INTRODUCTION

This chapter provides responses to the substantive comments on the Draft EIS (DEIS) made either verbally at the Public Hearings on the DEIS held on March 9, 2022 and April 13, 2022, or provided to the City of Yonkers Planning Board (the “Planning Board”), as Lead Agency, from February 2, 2022 through April 27, 2022. A list of commenters is provided below. The full transcripts of the Public Hearings and the correspondence from which the comments are drawn are included in **Appendix A**. Comments having a similar subject or raising similar technical points are grouped together. In some cases, for ease of reading, an introduction to a group of similar comments is provided (see e.g., Comment Gen-5).

AMS Yonkers Downtown Development

Construction Truck Turning Diagram - North Broadway
Phase 1 - 53-foot Tractor Trailer Entering Site

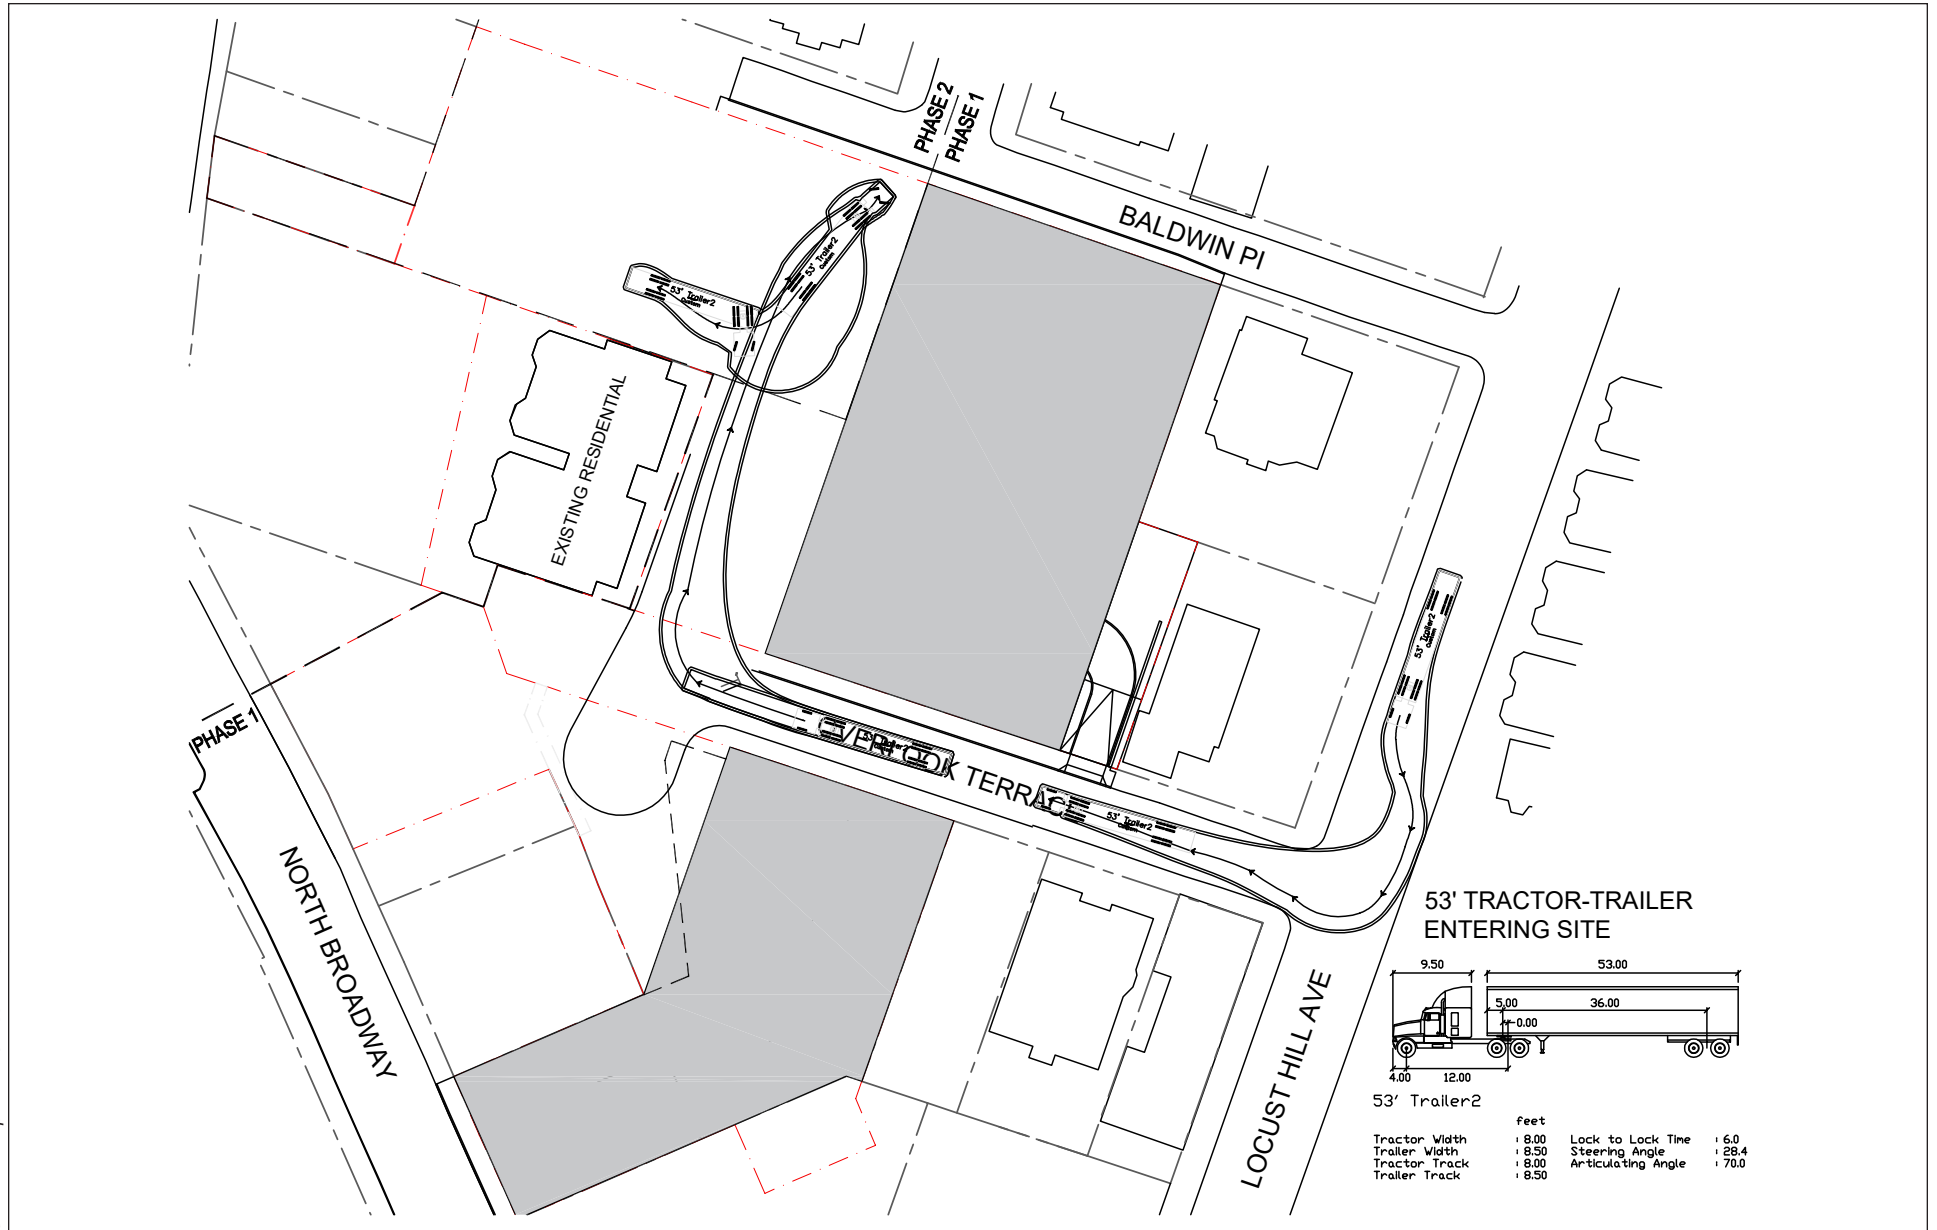
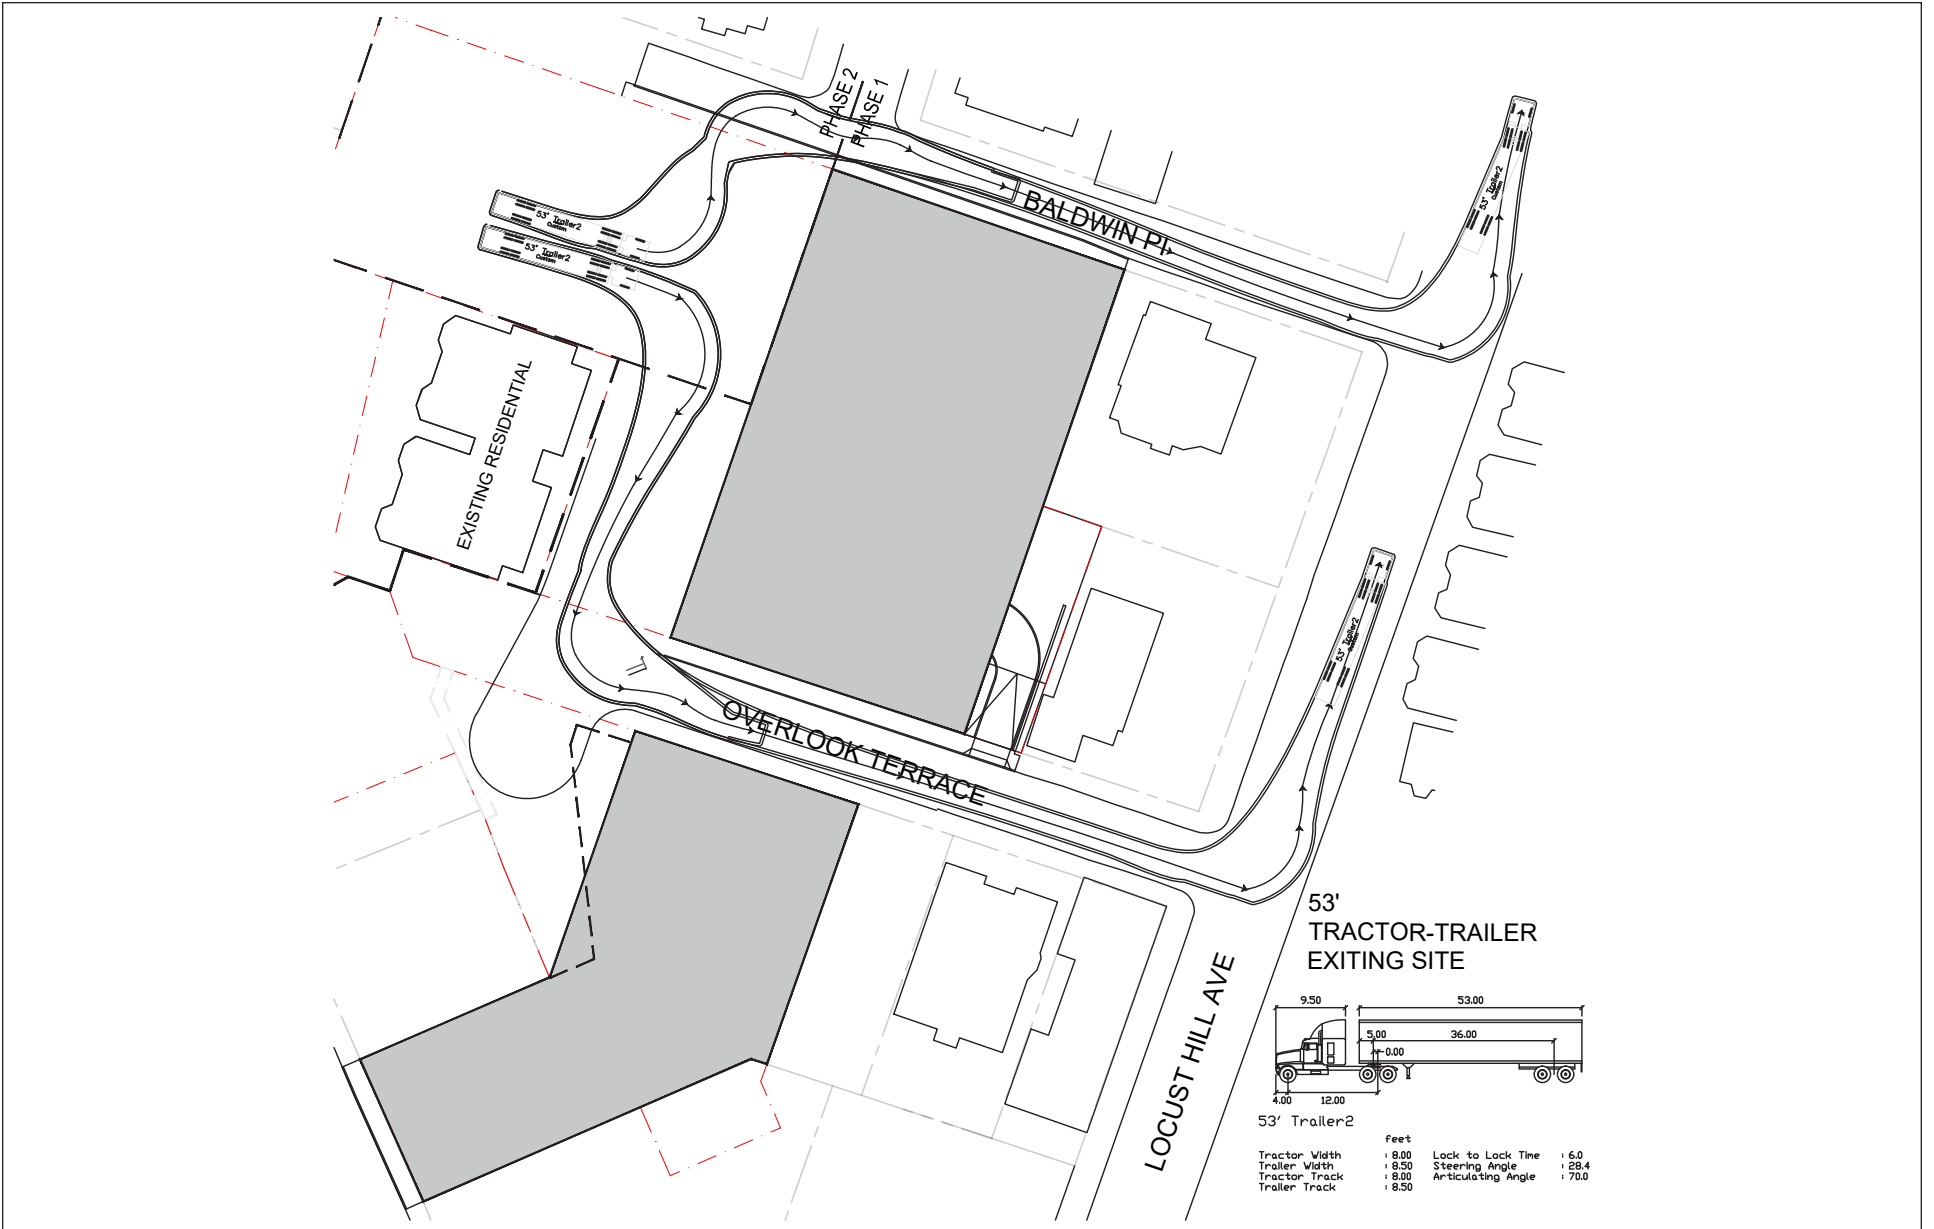
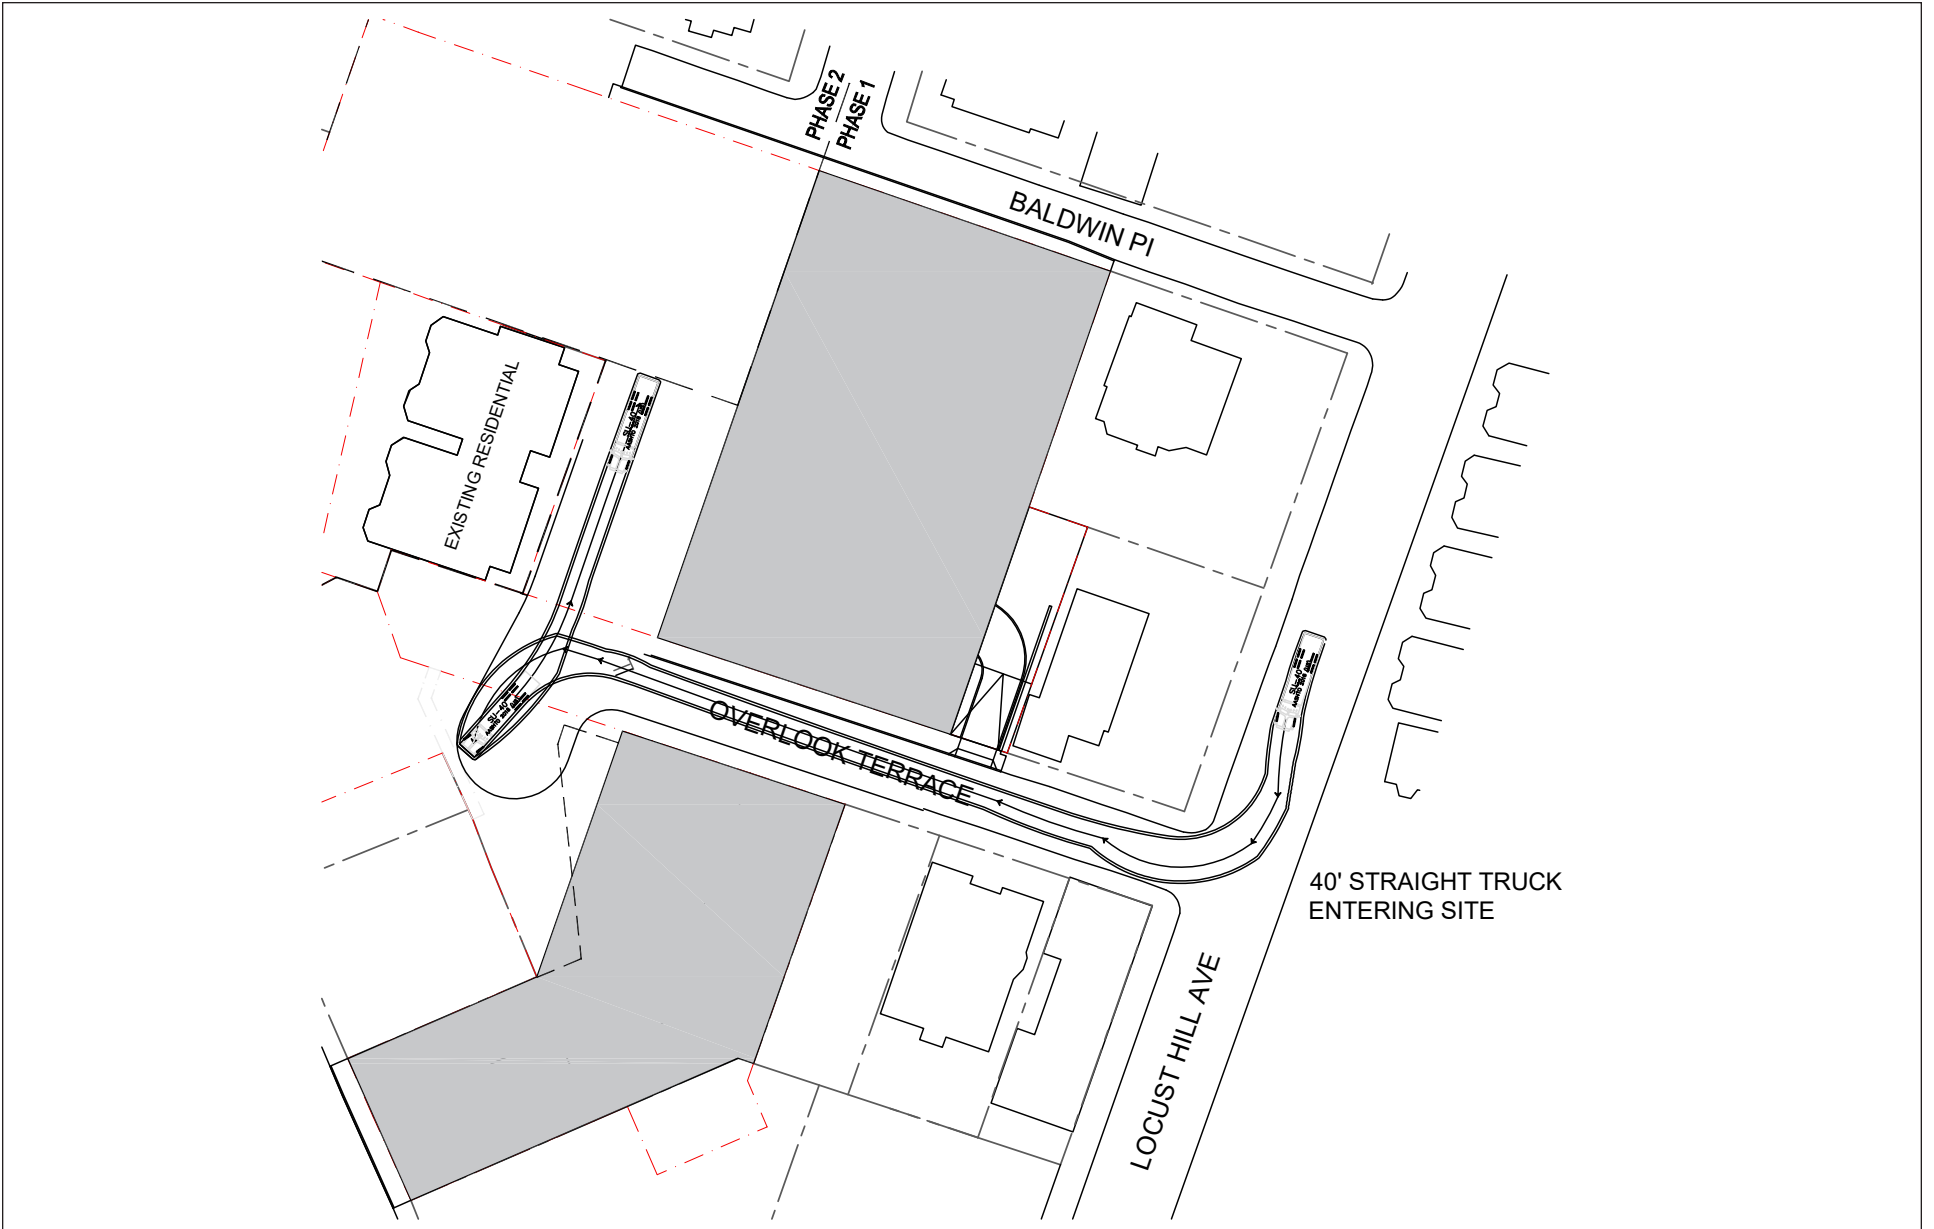
Figure 15-2 thru 15-12 Construction phasing diagrams – Understanding that these diagrams are schematic and draft they illustrate the improbability of statements made in the narrative that construction operations would take place on the sites. For example, materials delivery is almost inconceivable to be able to take place wholly on the Teutonia site without use of Buena Vista Ave for delivery with the then almost assured closures of the street to traffic. Therefore, alternate routes for traffic and drop off for area businesses and institutions at all of the sites need to be thought out during the EIS process. (Nersinger_031)

Same comment for the North Broadway Site and the projected figure of 2,400 truck trips for earthwork and excavation. Specific to this site, how will construction vehicles enter and exit the site? North Broadway is a one-way street near the site, and Locust Hill Ave, is narrow with a steep rise in grade from Palisade Ave. (Nersinger_031)

As described in Chapter 2, “Environmental Analysis,” of this FEIS, revised Construction Site Logistics Diagrams (included as **Appendix H-2**) and construction truck routing figures have been provided. The truck routing figures illustrate, conceptually, where trucks would stage and unload at each Project Site. Also shown, conceptually, is the extent of lane closures in front of the Project Sites. As part of Site Plan review and prior to construction, the revised Construction Site Logistics Diagrams would be finalized and would include the specific measures required to mitigate impacts from loading and unloading, including requirements for traffic control, time constraints and delivery hours of operations.

With respect to the Teutonia Site, the contractor would install a movable barrier parallel to the front lot line, approximately 15 feet from the lot line. Two-way traffic would remain on Buena Vista Avenue. This would be similar to the condition once the Modified Teutonia Project is completed, where, as previously described, only four on-street spaces would remain on the east side of Buena Vista Avenue in order to accommodate movement into the Hudson Street project’s off-Site parking lot and the Modified Teutonia Project garage and to accommodate the widening of the sidewalk between Prospect and Main Streets and the new left turn lane at Buena Vista Avenue and Prospect Street. Surrounding the North Broadway Site, on-street parking would be eliminated during construction on Overlook Terrace, Baldwin Place, and Locust Hill Avenue in the areas just north of Baldwin Place and Overlook Terrace. Similarly, closure of sidewalks at the intersections of Baldwin Place and Overlook Terrace with Locust Hill Avenue may be necessary. These restrictions would be necessary to allow for construction truck movements to and from Locust Hill Avenue to the North Broadway Site. The Applicant would require its Construction Manager, general contractor, and all sub-contractors to limit the size of construction trucks for the North Broadway Project to match the available roadway geometry in this area. Construction truck turning movements were evaluated for the North Broadway site (see FEIS **Figure 3-15**). Truck size would be limited to a 53-foot tractor trailer on Overlook Terrace and Baldwin Place during North Broadway Project Phase 1 and a 50-foot tractor trailer on Overlook Terrace during North Broadway Project Phase 2. Truck size limits would be incorporated in all subcontract and vendor agreements. Deliveries would be closely scheduled and confirmed by the Applicant’s Construction Manager’s site superintendents to avoid getting too many deliveries per day or at the same time. When the superintendents schedule these deliveries, they would remind the trucking companies of the truck size limits.
